**ATTACHMENT B  
NRC STAFF RESPONSES TO THE LICENSING BOARD'S  
INITIAL QUESTIONS REGARDING THE FEIS**

## **NRC STAFF RESPONSES TO THE LICENSING BOARD'S INITIAL QUESTIONS REGARDING THE FEIS**

**Figure 1**  
**Worst-Case 24-hour Total PM<sub>10</sub> Concentrations (Background plus *Highest* Concentrations from Emissions Related to the Proposed Action) during (a) Land Clearing Phase and (b) Building Construction Phase**

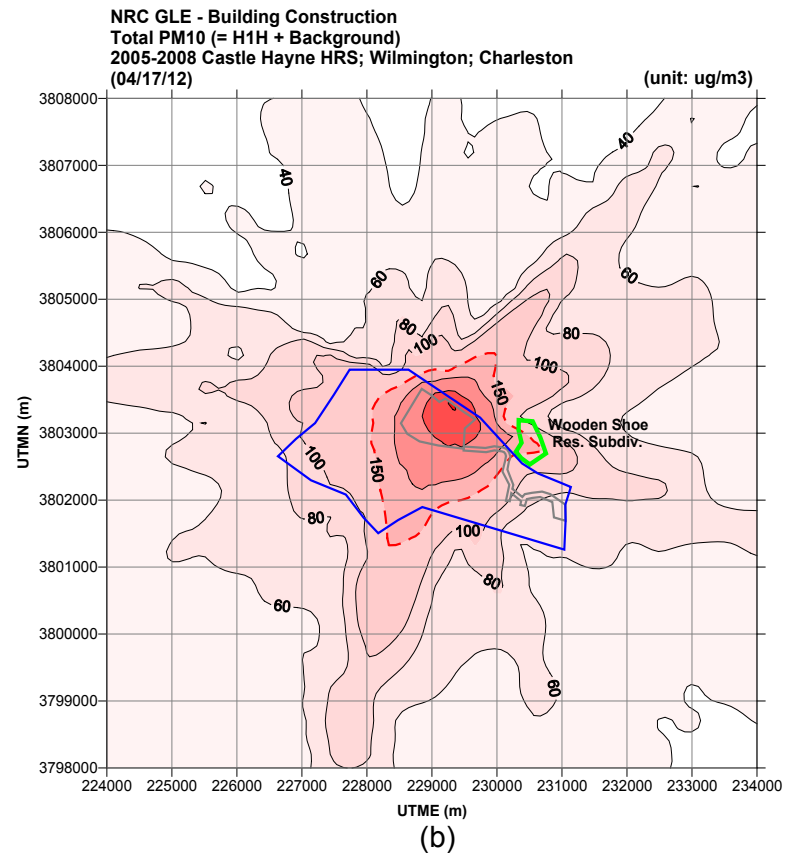
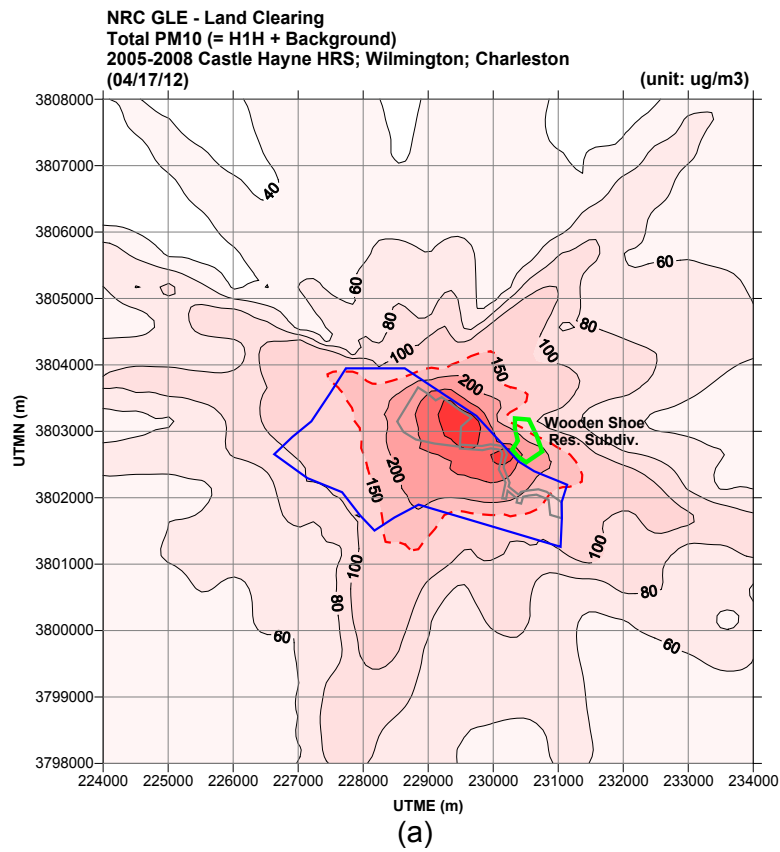
**FEIS Question No. 22:** *Twenty-four hour concentrations of particulate matter are predicted to exceed air quality standards during preconstruction and construction phases. How widespread will this decrease in air quality be? What effects are expected on the residents of the Wooden Shoe residential subdivision? (EIS 4-13)*

**Response No. 22 (Y.-S. Chang):** The worst-case concentrations of 24-hour total (background plus contribution from the proposed GLE Facility) particulate matter (PM), including coarse particulate matter (PM<sub>10</sub>) and fine particles (PM<sub>2.5</sub>), associated with land clearing activities are predicted to exceed the respective National Ambient Air Quality Standards (NAAQS) at the proximate northern boundary of the Wilmington Site near the proposed GLE Facility (less than 50 meters [164 feet] from the boundary). Comparably high PM concentrations are also predicted at the northern site boundary near the Wooden Shoe residential subdivision, close to which the North access road would be located (about 25 meters [82 feet] from the boundary). The high PM concentrations at the Wooden Shoe residential subdivision would result primarily from fugitive dust emissions during vehicle traffic on unpaved roads during the land clearing phase. On average, up to 2 and 3 days per year are predicted to have NAAQS exceedances for PM<sub>10</sub> and PM<sub>2.5</sub>, respectively, at residences adjacent to the North access road in the Wooden Shoe subdivision during the land clearing phase. As shown in Figure 1a (following this response), worst-case 24-hour total PM<sub>10</sub> concentrations (background plus *highest* concentrations from emissions related to the proposed action) over the NAAQS level during land clearing could reach approximately 0.6 mile (1.0 kilometer) from the Wilmington Site boundary near the proposed GLE Facility and about 0.3 mile (0.5 kilometer) from the northern site boundary near the Wooden Shoe residential subdivision. The concentration contours in Figure 1 represent the highest concentrations at each receptor over the modeling period, not an instantaneous 24-hour average for any single day. The worst-case total 24-hour concentration contours for PM<sub>2.5</sub> are wider than for PM<sub>10</sub>, but distances to the 24-hour NAAQS level are similar to that for PM<sub>10</sub>.

During building construction, predicted 24-hour total PM concentrations would exceed their respective NAAQS beyond the site boundary, mostly to the north of the proposed GLE Facility. However, an average of less than one exceedance per year is anticipated to occur in the Wooden Shoe residential subdivision because the subdivision is about 0.8 mile (1.3 kilometer) east of the proposed GLE Facility site, just off the prevailing southwesterly winds, and because the North access road would be paved at the conclusion of the land clearing phase. As shown in Figure 1b (following this response), the worst-case 24-hour total concentration contours for PM<sub>10</sub> during building construction are smaller than during land clearing, but the distances to the NAAQS level are similar. The same is true for PM<sub>2.5</sub> during land clearing and building construction.
